W3F1-2003-0090

SUBJECT: Response to Request for Information Related to Review of Refuel 11
Steam Generator Tube Inservice Inspection Report SR-03-001-00
Waterford Steam Electric Station, Unit 3
Docket No. 50-382
License No. NPF-38

Response to Request for Additional Information

Figure 5.1

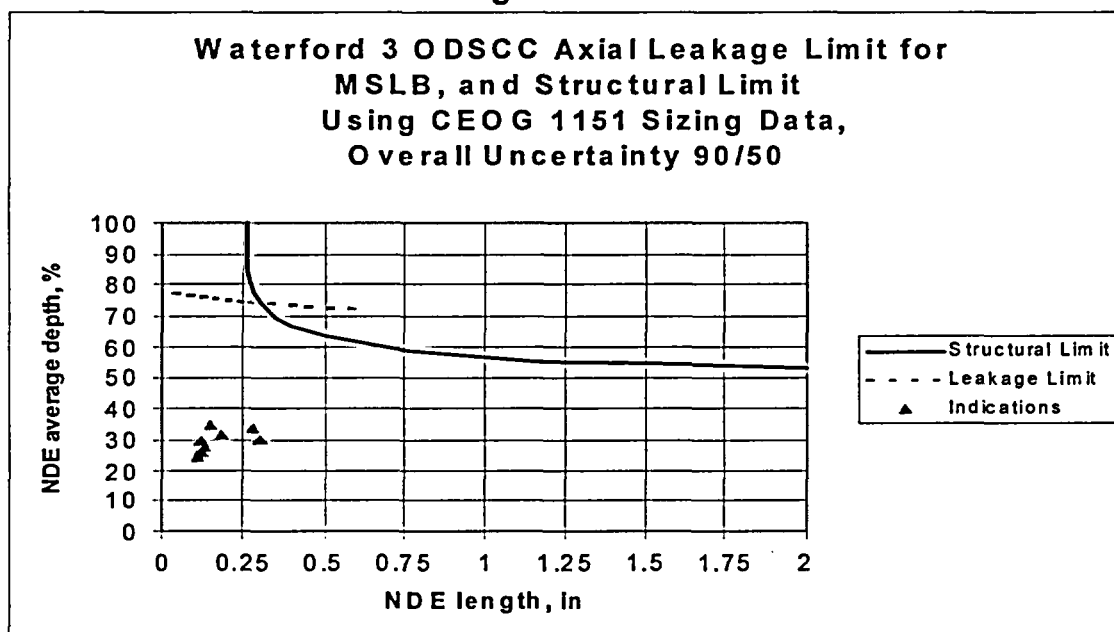
Please provide a list similar to Tables 1 and 2 of all flaws found during the inspection (axial, circumferential, and volumetric). Wear flaws at tube supports (egg crates, batwings, vertical straps) do not need to be included in this list.

5.1 Assessment of Axial ODSCC

Assessed Indications		OD Axials			
NDE length, inch	Ave. Depth, %	SG	Row	Col	Supt
0.13	27.9	31	63	17	TSH
0.3	30	31	46	58	04H+.5
0.28	33.8	31	64	66	03H+.7
0.18	31.9	31	90	154	TSH
0.12	26.2	31	4	162	TSH
0.12	29.4	31	4	164	TSH
0.15	34.9	31	9	169	TSH
0.11	24.8	31	7	171	TSH

All indications fall well below the structural and leakage limits which assure that the structural and leakage limits are satisfied with significant margin.

**SG Tubesheet Map and
Tube Support Naming Convention**

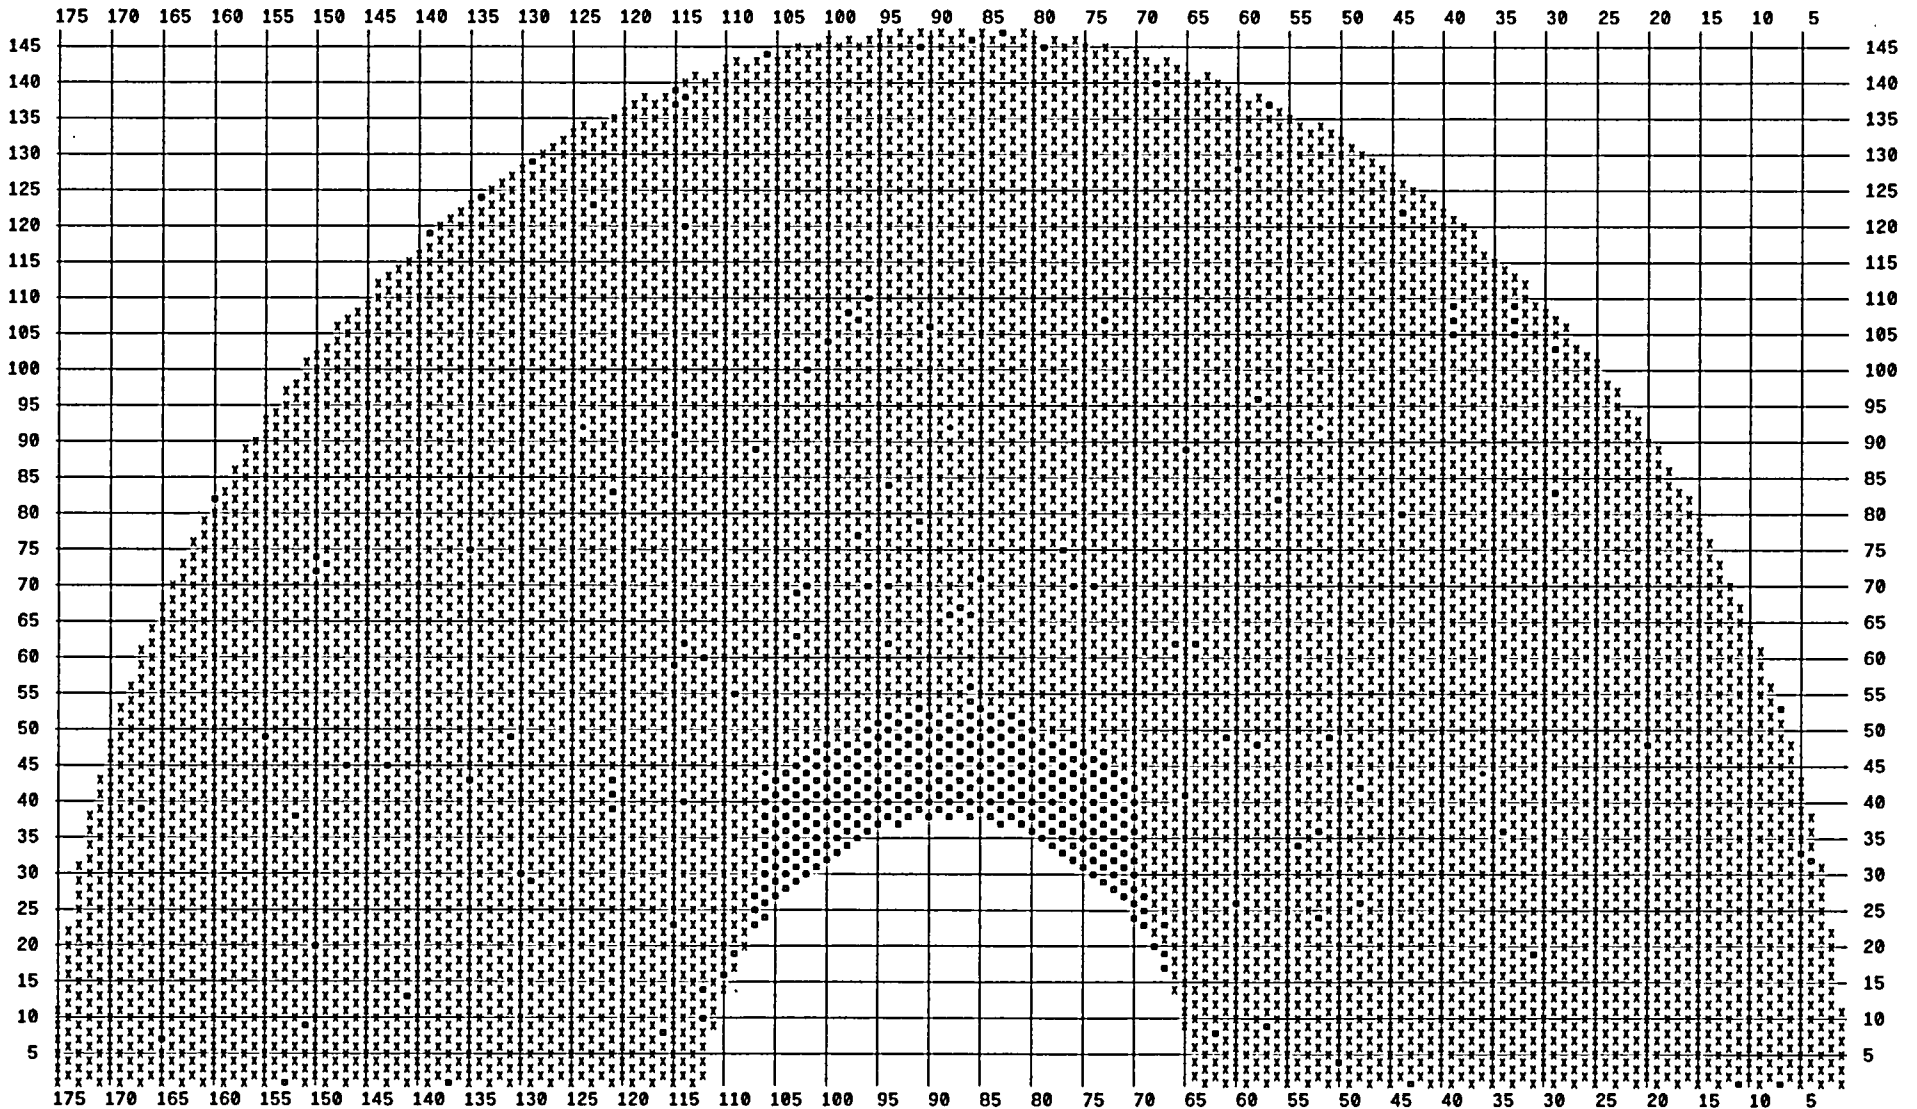
Please provide a tubesheet map and your tube support naming convention.

A SG tubesheet map and tube support naming convention is provided in Attachment 3. The tubesheet map is a computer generated map of one-half of SG 32. The tube support naming convention is an excerpt from Waterford 3's Data Analysis Guidelines (Reference 6). Please contact us if you have additional questions regarding readability.
